**Special Standard
PUD Zoning District**

Project Name: GRANDVIEW PHASE II

PCD File No.: PUDSP-236

DEVIATION REQUEST (Attach diagrams, figures, and other documentation to clarify request)

Modified Urban Minor Arterial Cross Section

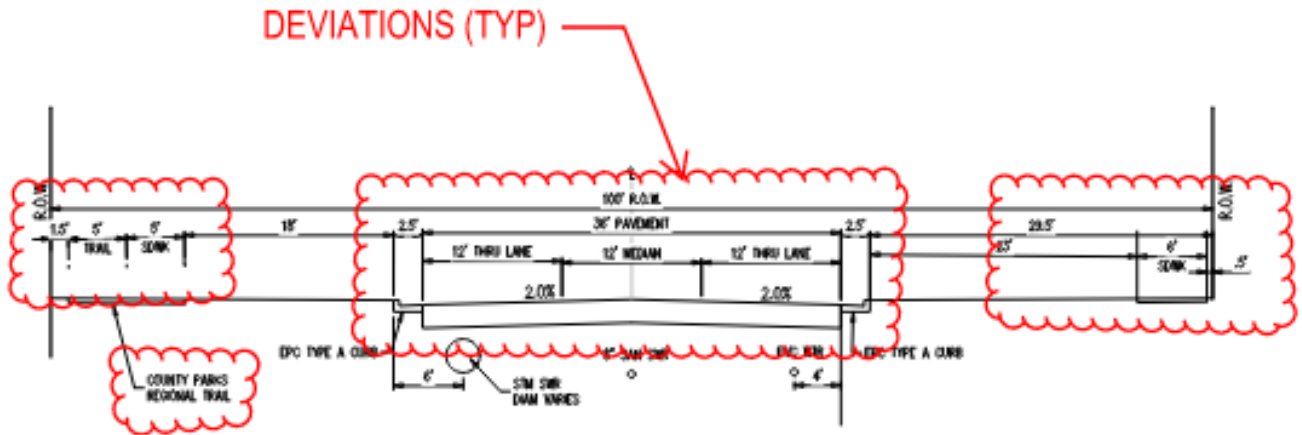
Deviation from Figure 2-13. Typical Urban Minor Arterial Section. The figure shows the typical cross section with a pavement width of 62' and a tree lawn of 7'. The Modified Urban Minor Arterial Section ((2 Lane) proposes a pavement width of 36' and tree lawn widths of 18' and 23' but maintains the 100' R.O.W. The 2-lane section is consistent with the County MTCP (adopted 2024-07-18) Which identifies the road as an Urban Minor Arterial (2 lane) (See Snips from MTCP below).

Figure 2-13. Typical Urban Minor Arterial Cross Section

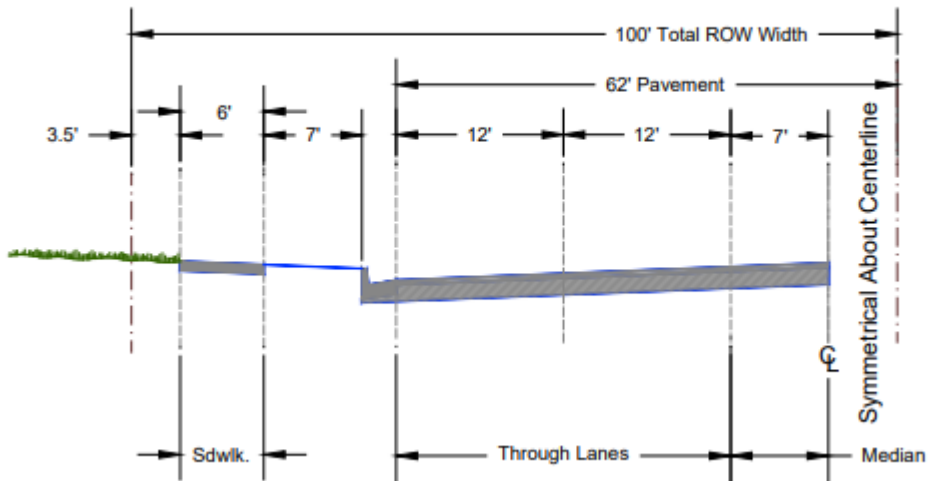
- 1.) The deviation based on road class and lane configuration from the County MTCP and modeling in the TIS.
- 2.) The deviation is comparable to the standard design by providing sufficient lanes to safely convey peak volumes of traffic as determined by the traffic study.
- 3.) The deviation enhances pedestrian safety by increasing the distance between the sidewalk and roadway.
- 4.) The deviation reduces maintenance costs by providing a smaller pavement width.
- 5.) The deviation enhances aesthetic appearance by providing a larger landscape lawn between the roadway and sidewalk.
